DATE: July 30, 2019
TO: Blue Bird Owners
Subject: **RECALL R18ZN, HSM NextGen (School Bus) Seat with Integrated Child Restraint Belt System Warning Label**

IMPORTANT SAFETY RECALL NOTICE

NHTSA Recall Number: 18V-566 School Bus

RECALL #18E083 SERVICE REPAIR PROCEDURE #1801-0012

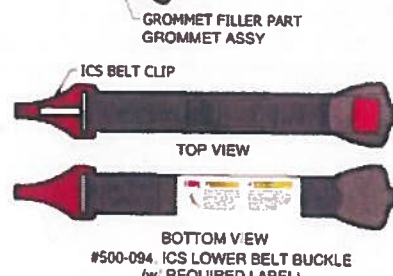
- STEPS TO REPLACE BELT:**
- 1 FIRST CHECK WHETHER ICS LOWER BELT BUCKLE NEEDS REPLACED. IF CURRENT ICS BELT DOES NOT HAVE LABEL, PROCEED WITH REPLACING BELT.

- 2 ASSURE ALL NEEDED PARTS/ITEMS ARE AVAILABLE.
 - 3 UNLOCK CUSHION AND PLACE IN UPWARD POSITION. TO UNLOCK PLACE KEY IN PLUNGER, TWIST TO SET AND PULL OUT TO D SENGAGE. SEE ILL #5

- NOTE: CAN KEEP CUSHION UNLOCKED TO ALLOW FOR QUICKER REPLACEMENT, (INSTALLER PREFERENCE)
 - 4 TO ACCESS #500-094 ICS LOWER BELT BUCKLE ATTACHMENT POINT, OPEN BOTTOM OF CUSHION COVER BY UNFASTENING HOOK AND ARROW ON SIDE OF CUSHION WHERE ICS BELT IS LOCATED. SEE ILL #2

- 5 LOCATE ICS BELT CLIP AND UNHOOK. WHEN (2) ICS POSITIONS, INSTALL ONE AT A TIME. SEE ILL #2.
 - 6 ROTATE CUSHION INTO DOWNWARD POSITION
 - 7 PULL BUCKLE END OF BELT, THE PULLING MOTION MAY LOOSEN GROMMET FILLER PART AND ALLOW ENTIRE BELT TO BE REMOVED.

- 9 GUIDE ICS BELT CLIP FIRST THROUGH GROMMET, ASSURE BELT ORIENTATION IS CORRECT.
 - 10 ROTATE CUSHION IN UPWARD POSITION.
 - 11 ATTACH ICS BELT CLIP INTO CUSHION FRAME ICS ROD, ASSURE BELT AND BELT CLIP ARE ON BOTTOM SIDE OF CUSHION FOAM AND FLEXMAT.

- 14 PLACE GROMMET FILLER PART BACK INTO GROMMET, ASSURE FILLER PART IS FLUSH WITH REMAINING GROMMET ASSY.
 - 15 ASSURE CUSHION IS LOCKED IN THE DOWNWARD POSITION.

#500-094, ICS LOWER BELT BUCKLE
(w/ REQUIRED LABEL)

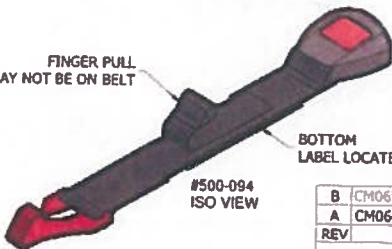
1. FIRST CHECK WHETHER ICS LOWER BELT BUCKLE NEEDS REPLACED. IF CURRENT ICS BELT DOES NOT HAVE LABEL, PROCEED WITH THE ADDITION OF LABEL 800-651-HT.
2. LOCATE LABEL AS SHOWN ON BELT 500-094 BOTTOM VIEW. ASSURE LABEL IS LOCATED ON BOTTOM OF BELT.
3. USE HEATED HAIR STRAIGHTENER OVER BELT AND LABEL. GLIDE HAIR STRAIGHTENER BACK AND FORTH SLOWLY AS NEEDED TO ACTIVATE LABEL HEAT TRANSFER.
NOTE! SEE ILL #2 TO SEE VISUAL DIFFERENCE OF ACTIVATED HEAT TRANSFER ON LABEL.
NOTE! USE CAUTION TO NOT KEEP HAIR STRAIGHTENER IN ONE AREA TOO LONG. THIS WILL AVOID OVERHEATING THE LABEL THAT COULD CAUSE DAMAGE/LEGIBILITY
4. ASSURE LABEL DOES NOT MOVE WHILE ACTIVATING HEAT TRANSFER.
5. CHECK THAT LABEL HEAT TRANSFER IS FULLY ACTIVATED ON WEBBING. ANY QUESTIONABLE AREAS REPEAT STEPS 2 - 5.
